Product Change Notification - LIAL-26MGJS550

CCB 4145 Final Notice: Qualification of MTAI as a new final test site for selected Atmel AT21CS01 and AT21CS11 device families available in 3L SOT-23 (1.3mm) package.

PCN #: LIAL-26MGJS550

CCB 4145_ Pre and Post Changes Summary

Packing Information – Tape and Reel

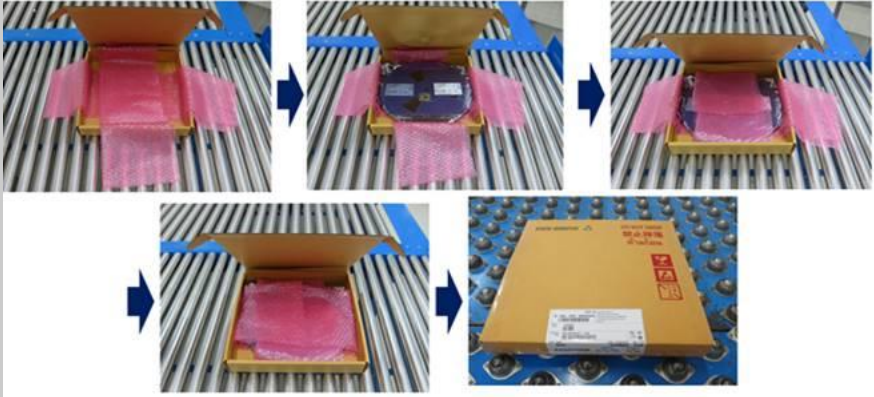
Pre-Change					Post Change				
Final Test Location	ATP7					MTAI				
Packing Media	Tape and Reel					Tape and Reel				
Base Quantity Multiple (BQM)	5000					5000				
Pin 1 Orientation	Quadrant 3					Quadrant 3				
With Desiccant and HIC?	Not Applicable					Not Applicable				
Carrier Tape	Width	Pitch	A0	B0	K0	Width	Pitch	A0	B0	K0
	12mm +/- 0.3	4mm +/- 0.1	3.21mm +/- 0.1	2.65mm +/- 0.1	1.25mm +/- 0.1	8 mm +0.3/- 0.1	4 mm +/-0.1	3.15 mm +/-0.1	2.77 mm +/-0.1	1.22 mm +/-0.1
Cover Tape	Width		Thickness			Width		Thickness		
	5.4mm		0.053mm			5.4 mm +/-0.1		0.062 mm +/-0.013		
Reel	Color		Diameter			Color		Diameter		
	White		13 inch			Dark Blue		13inch
